# **On-site Soil Investigations**

**Keuka Road, Concord, Massachusetts**

**Requested by: Concord Conservation Commission**

# **On-site Investigations Report**

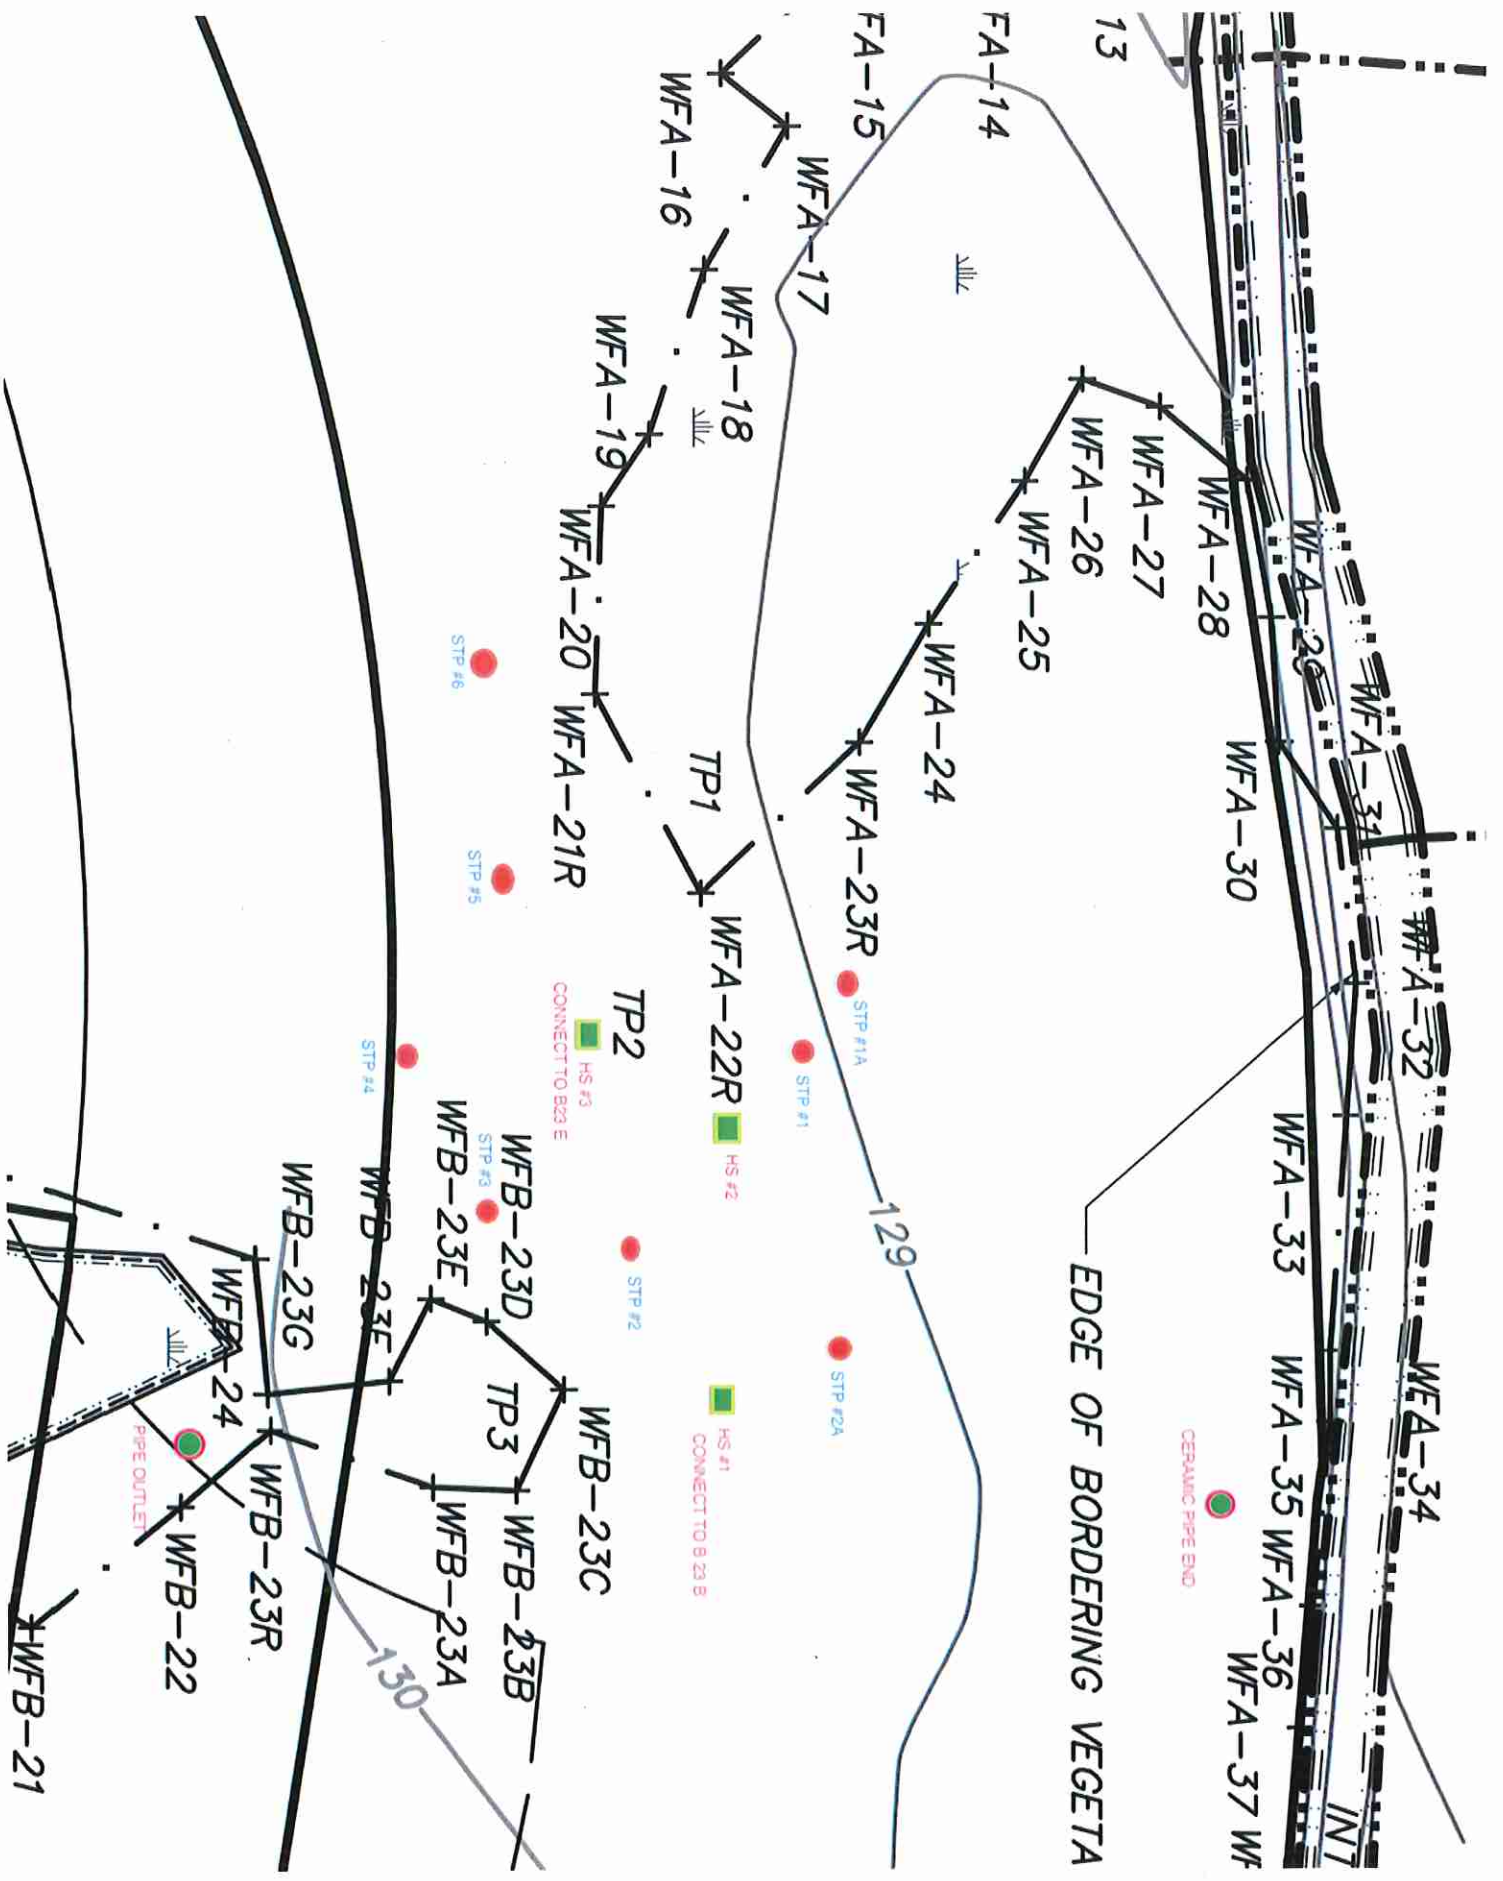
The on-site soil investigations conducted for this report confirm that there is a relatively narrow band of upland soils that separate the wetland to the northwest (WFA-19 through WFA-22R) from the wetland to the southeast (WFB-23R through WFB-24 ). These investigations confirm that the extent of wetland soils (hydric) is greater than those shown on the Resource Area Delineation Plan (revised 10/15/2013), prepared by Markey & Rubin Civil Engineers. Refer to the attached enlarged section of the Resource Area Delineation Plan for the location of the wetland soil line (hydric) confirmed by these on-site soil investigations.

The images on the 1952 and 1960 aerial photographs indicate that there may have been a ditch that connected a wetland in the southern portion of the Site to the ditch that parallels the northern boundary of the Site. This was confirmed on the 1913 McCallar Tract, Concord, Mass. Site Plan. The 1960 imagery indicates that the northern portion of this ditch may have been covered over with earthen material.

At the end of the day following the soil investigations described in this report, the location of a suspected buried clay drainage tile was investigated. Using a tile probe it was confirmed that there was a buried clay drain tile within the area of concern. Preliminary investigations confirmed that there is a submerged end of a clay tile in the ponded area located in the southwestern portion of the Site and shown on the Resource Area Delineation Plan. These investigations then indicate that a buried section of this pipe continues in a northerly direction through the wetland area in the general vicinity of Wetland Flags WFB-23R and WFB-24. Preliminary investigations along the southern edge of the ditch that parallels the northern edge of the Site confirmed a buried section of clay drainage tile that outlets into a small swale on the southern bank of the drainage ditch. It is suspected that these clay tiles are connected, and the southern end is the inlet and the northern the outlet. The description of the outlet for the clay drainage tile is inaccurate on the Resource Area Delineation Plan (revised 10/15/2013). The outlet is labeled "PIPE OUTLET CRUSHED PIPE". Unless the Applicant's Wetland Consult has constructed additional investigations, my preliminary investigations indicated that the clay drainage pipe was not crushed.

Because these investigations were conducted at the end of the day there was only time to confirm the presence of the buried clay drain tile, but not enough time to evaluate the soil characteristics in the vicinity of the pipe. The Applicant's consultant was unaware of the buried clay drainage tile and did not address this in his report. It is recommended that additional investigations be conducted to determine the location of the clay tile, verify its current

condition, examine the soils along the pipe, and determine if the outlet of the clay drainage tile connects to the wetland area that borders the ditch to the north.

If a hydrologic connection is confirmed between Wetland WFA and Wetland WFB, the wetland line for Wetland WFB will have to be checked in the field.
